**Re: DART+ WEST ELECTRIFIED RAILWAY ORDER 2022
CASTLETHORN AND CHARTERED LAND GROUP SUBMISSION WITH RESPECT
TO THE IMPACT OF THE ASHTOWN ROAD IMPROVEMENT WORKS ON OUR
LANDS AT ASHTON HOUSE.**

ASHTOWN ROAD UPGRADE & ENTRANCE TO ASHTON HOUSE

Architectural Heritage Impact Assessment of the Proposed Alternative Entrance Route to Ashton House, Ashtown, Co. Dublin

Fig 1: Extract from Waterman Moylan Sketch Design of Proposed Alternative Junction and Access to Ashton House

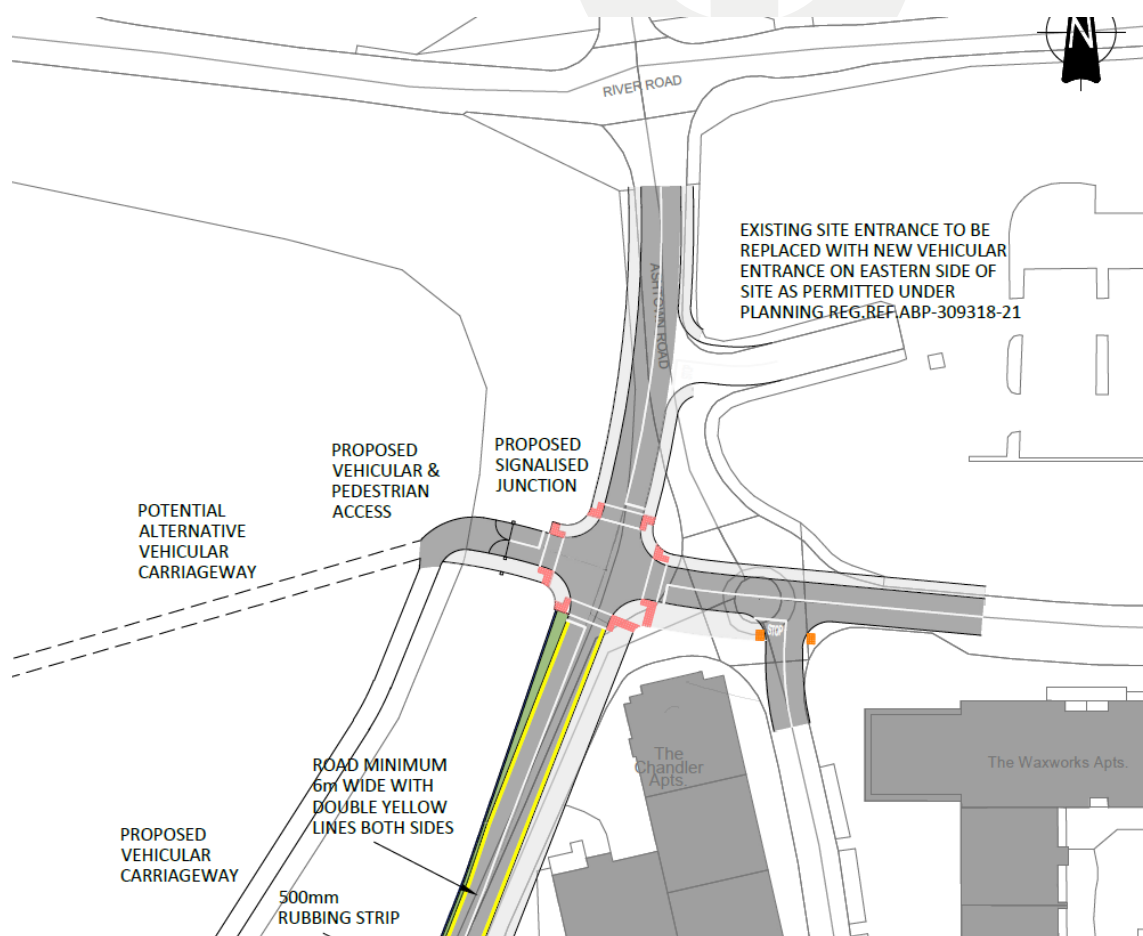
It is submitted that the existing roundabout junction should be re-examined, as supported by our consultant engineers, Waterman Moylan, to give greater legibility to the new Ashtown Road corridor alignment and to ensure adequate capacity at this junction between Ashtown Road and Rathborne Avenue to accommodate the anticipated volumes of traffic including Dublin Bus services within the surrounding and evolving road network. We would respectfully request that the scope of works to Ashtown Road as part of DART+ West be extended to fully include this roundabout, that this junction be repositioned and redesigned and a new purpose-planned vehicular and pedestrian entrance directly west off this reconfigured junction be accommodated to serve Ashton House (see Figure 1 below).

We include a preliminary drawing from Waterman Moylan Consulting Engineers which shows this amended junction as a simple priority '4-arm' junction. This junction could be signalised as necessary and it re-establishes the original alignment of Ashtown Road as the priority route off which Rathborne Avenue and Rathborne Village are accessed to the east, and Ashton House to the west, respectively.

It is more pedestrian and cyclist friendly than a roundabout and consequently a more DMURS compliant junction arrangement. Consideration can be given to signalisation, at the outset if necessary, or when the Ashton House lands are developed as appropriate and subject to planning. A local road access and footpath served by a priority junction onto the realigned Ashtown Road is a comparable like-for-like vehicular access arrangement to our lands.

Drawing showing Iarnrod Eireann proposal (shown in grey), overlaid on existing conditions (shown in red).

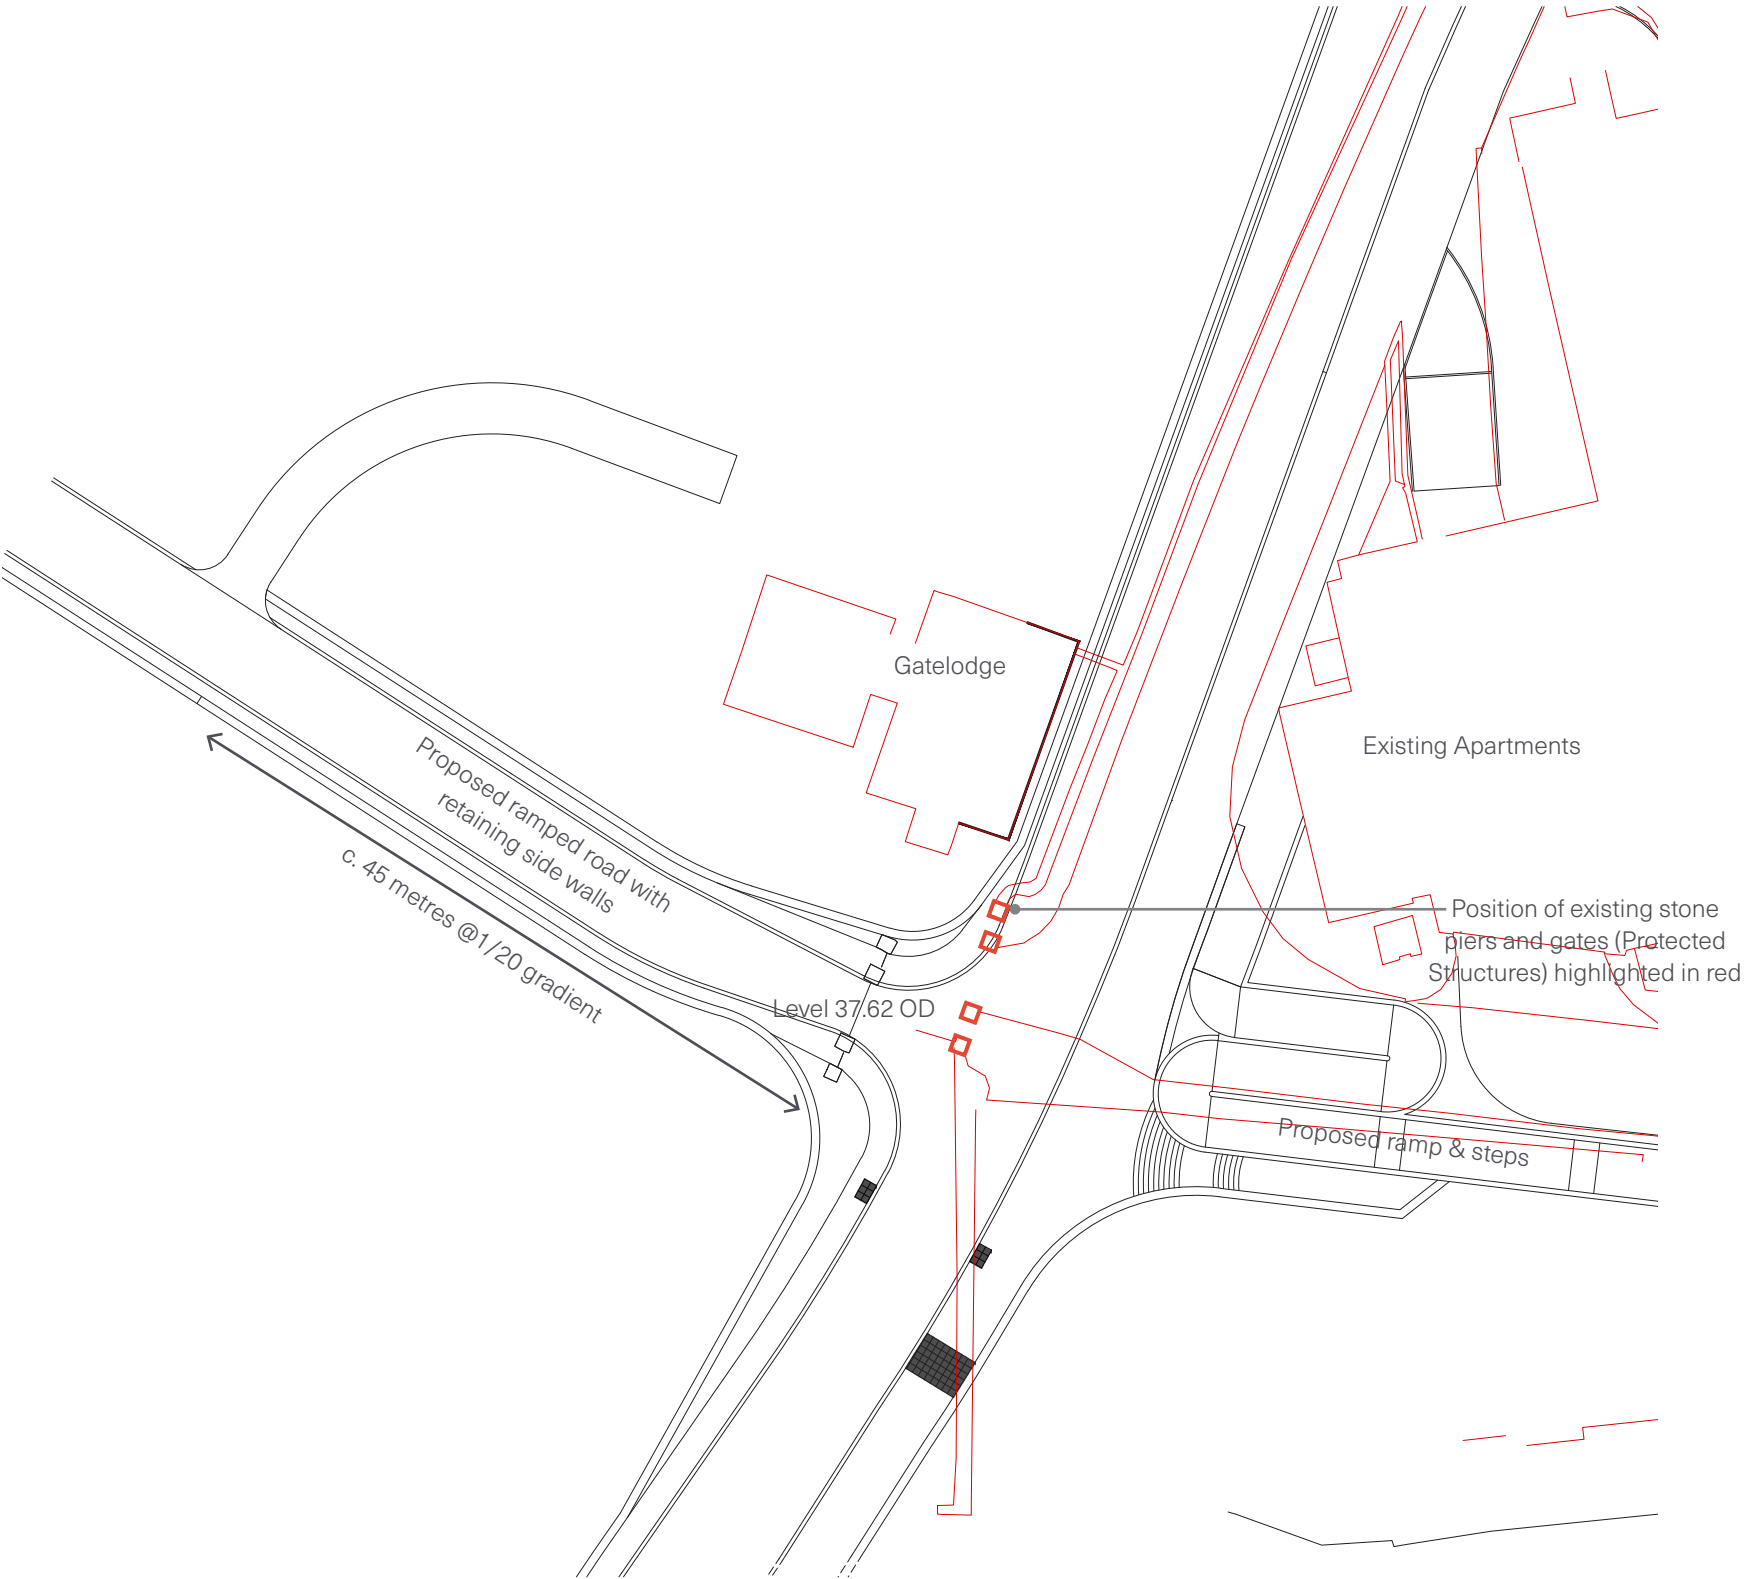
Iarnrod Eireann have proposed that the existing position of the stone piers & gates (Protected Structures) be removed and reconstructed in a position slightly south-west of their existing location, and that they would be placed at the level of the proposed Ashtown Road upgrade, i.e. c. 2.74 metres below their existing level.

Iarnrod Eireann have proposed that the newly positioned piers would continue to serve as the point for vehicular and pedestrian access to Ashton House, and propose that a ramped road, which would be c. 40-45 metres in length, located inside the grounds of Ashton House, would navigate the proposed level change of c. 2.7 metres between the Ashtown Road upgrade and existing ground levels. Retaining walls will be required on the sides of the ramped road to deal with the level difference between the road and the adjacent ground levels.

We are concerned that the proposed entrance condition will create an unsafe, unpleasant, “tunnel” or “underpass” effect for entrants into Ashton House, and will sever the relationship between the existing stone piers & gates and the gatelodge, all of which are Protected Structures.

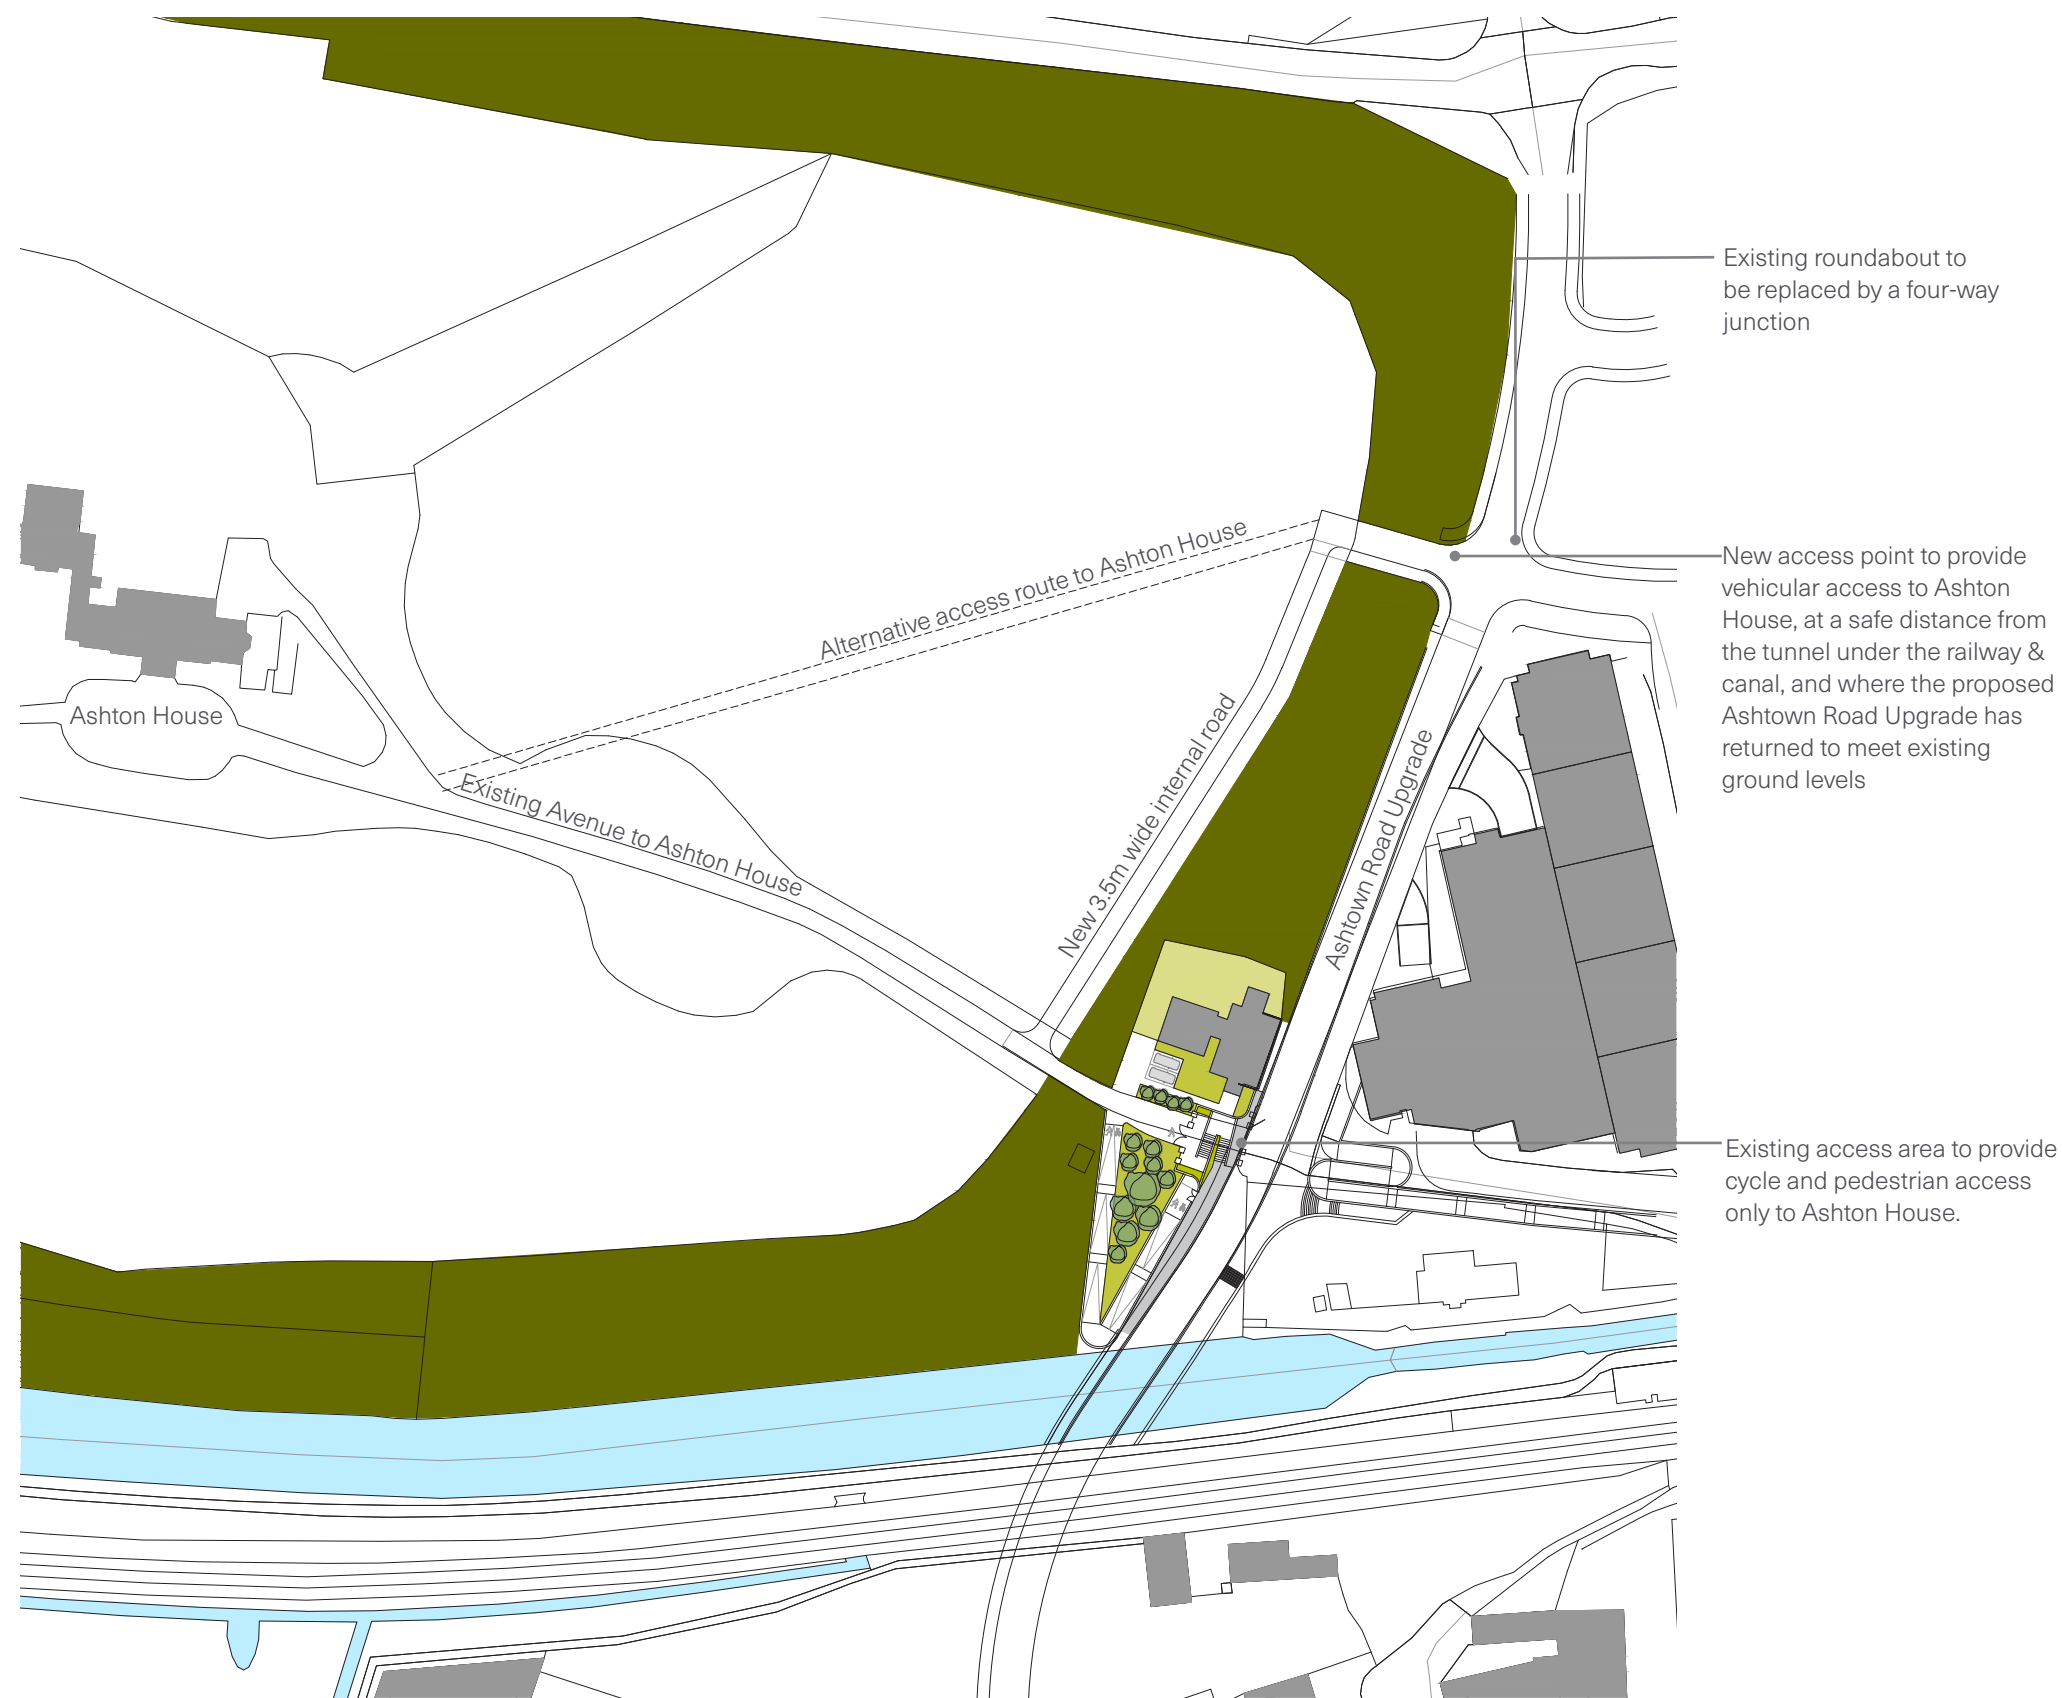
Proposed Ashtown Road Upgrade & Ashton House entrance by Iarnrod Eireann, with change in ground level of c.2.7metres at the existing entrance to Ashton House. As can be seen in the 3d model, the stone piers and gates are dwarfed by the scale of the retaining walls required by the Ashtown Road Upgrade, and the relationship between the stone piers & gates and the Gatelodge is severed.

Figure 10: Plan of the Iarnród Éireann proposed alterations to Ashton Road shown in red, overlaid on the existing Ordnance Survey map. Drawing prepared by OMP Architects.

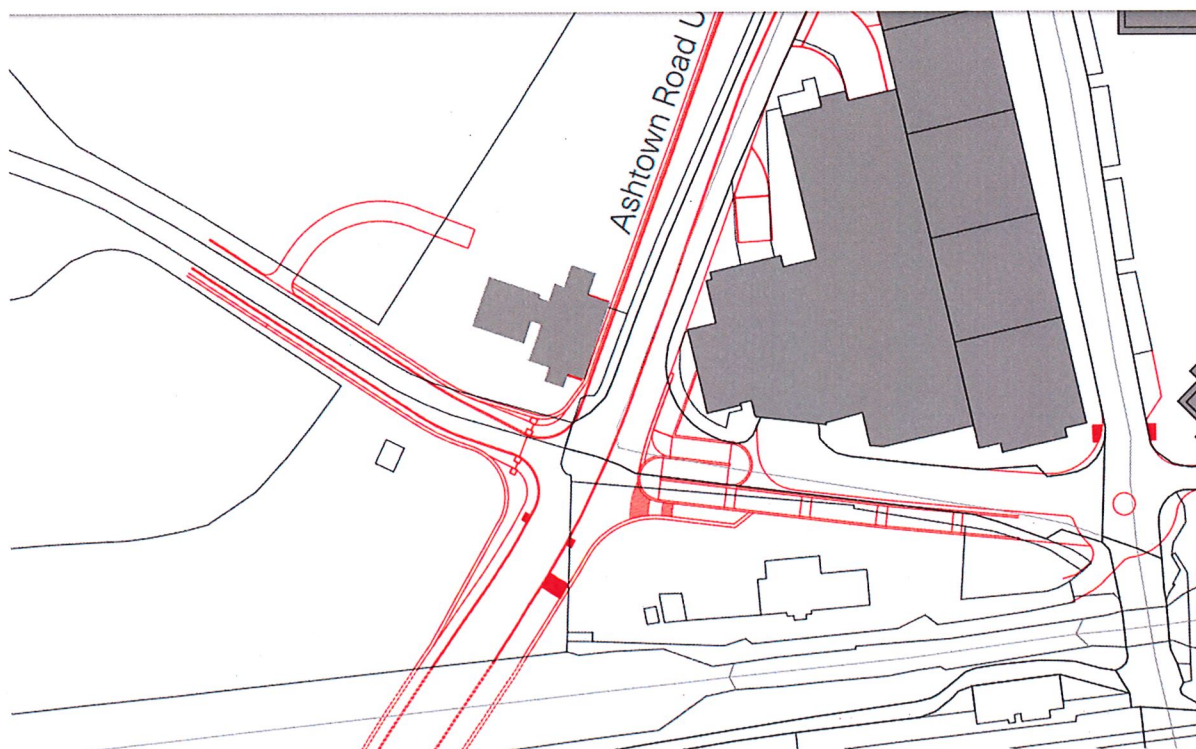
The most significant feature of this proposal is the widening, realignment and level changes of Ashtown Road. This will necessitate the relocation of the existing gate piers and gates to a level far lower than the gate lodge itself, along with the demolition of the existing rendered boundary wall to Ashton House. The works will have the effect of creating a curved tunnel below the gate lodge and will remove the gate lodge from view and dwarf the gate piers which will be at a much lower level, disconnecting the gate lodge and entrance setpiece. These upgrade works to Ashtown Road will have a significant impact on the character of Ashtown Road, and on the contribution of the boundary features of Ashton House to the streetscape.

Option A includes a change of level along the entrance avenue, and the construction of retaining walls on either side of the avenue. The existing historic gates and gate piers (Protected Structures) will be relocated slightly to the west, at the proposed new ground level. The high retaining walls required for these works will have a significant impact on the character of the historic estate and the setting of Ashton House, altering the landscaping within the estate, and impacting significant vistas along the entrance avenue and within the setting of the Protected Structure.

The proposed new retaining walls will also impact the architectural character of the Ashton House estate as viewed from the public realm, with the retaining walls to either side of the entrance avenue limiting views of the parkland and creating a tunnel-like appearance. The high retaining walls will sever the existing visual connection between the Gate Lodge and Gate Piers/Gates, eroding the significance of this ensemble of entrance structures.

Figure 11: 3D model showing Option A, proposed by Iarnród Éireann. Prepared by OMP Architects.

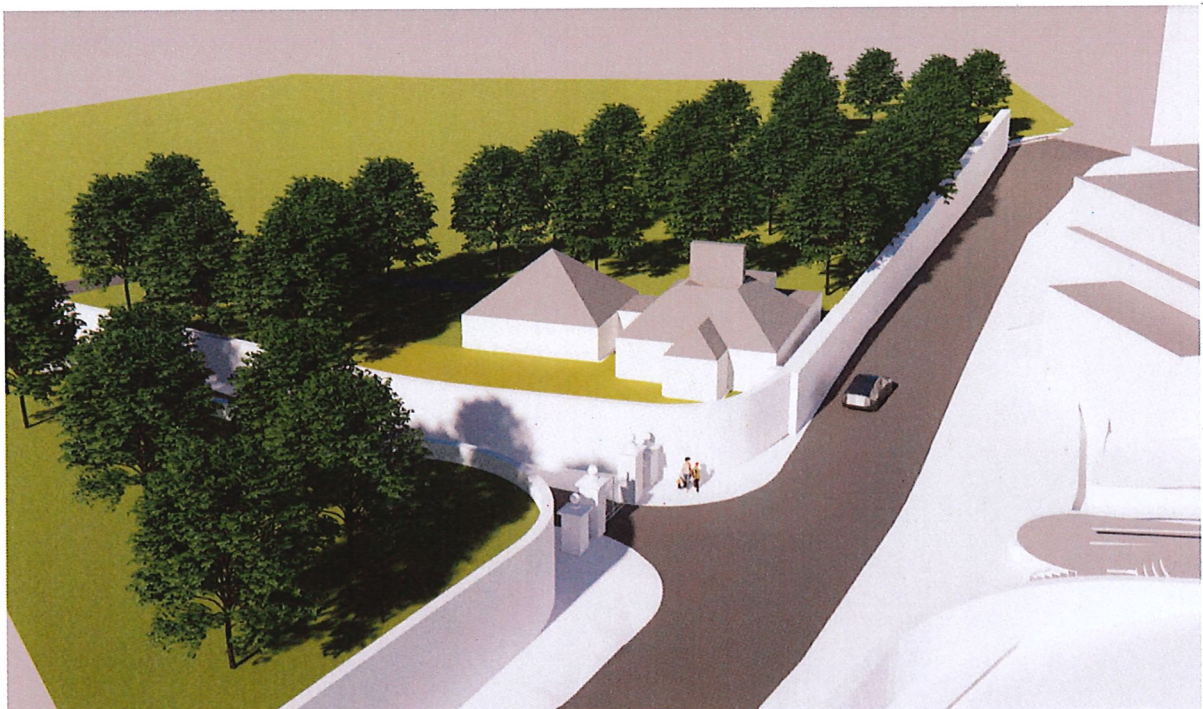
The proposed works within Ashton House lands are considered to be an irreversible and inappropriate intervention to the setting of this Protected Structure, which will have a

significant deleterious impact on the character of the setting and on views and vistas within the estate. The works will undermine the significance of the gates/gate piers and Gate Lodge through their separation by a tall retaining wall, and will completely alter the character of the Ashton House estate and its contribution to the streetscape.
